MFN 06-344

Docket No. 52-010

Subject: **Response to Portion of NRC Request for Additional Information
Letter No. 54 Related to ESBWR Design Certification Application –
Radioactive Waste Management – RAI Numbers 11.2-11, 11.2-12,
11.2-14, 11.3-1 and 11.3-3**

Figure 11.2-2. Liquid Waste Management System Process Stream Information Directory

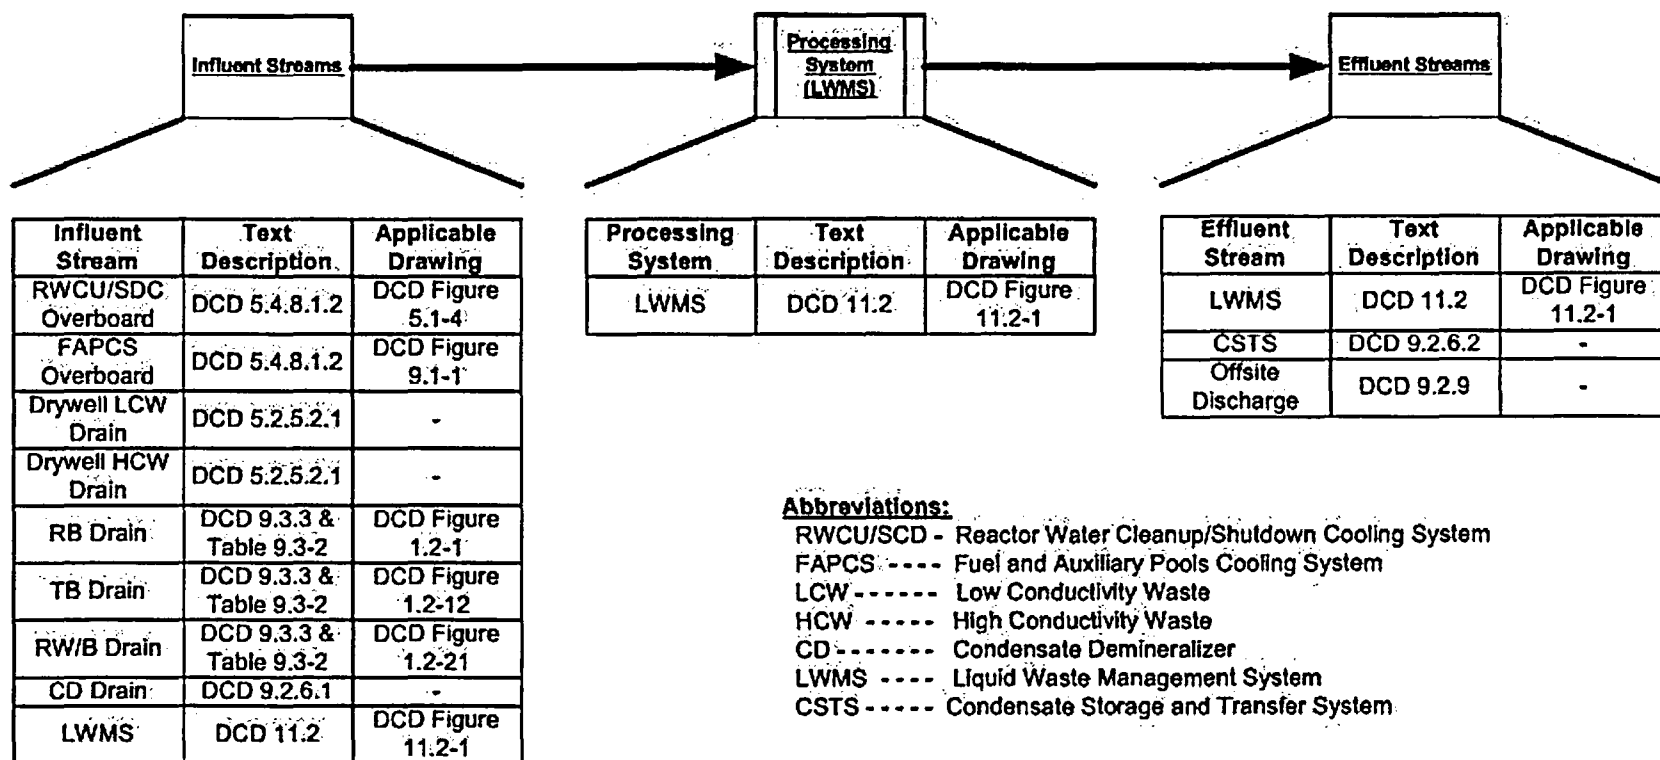
DCD Tier 2, Figure 11.2-1, "Liquid Waste Management System Process Diagram," does provide sufficient detail to assess the system's adequacy. Locations of components relative to other plant components and buildings are not shown. Update the diagram to include sufficient detail to identify all sources of liquid input volumes (e.g., condensate storage tank collection berm and individual building sumps), the points of collection of liquid waste, the flow paths of liquids through the system including all bypasses, and the specific points of release of liquid effluents to the environment (e.g., interface COL item with circulating water system), consistent with the guidance of Standard Review Plan (SRP) Section 11.2, Rev. 2, July 1981, Review Criterion III.1.

DCD Tier 2 Chapter 11 will be revised to include a new Figure 11.2-2, "Liquid Waste Management System Process Stream Information Directory." Additionally, a description of Figure 11.2-2 has been added in Section 11.2. These attached improvements to the DCD are consistent with the guidance of Standard Review Plan (SRP) Section 11.2, Rev.2, July 1981, Review Criterion III.1.
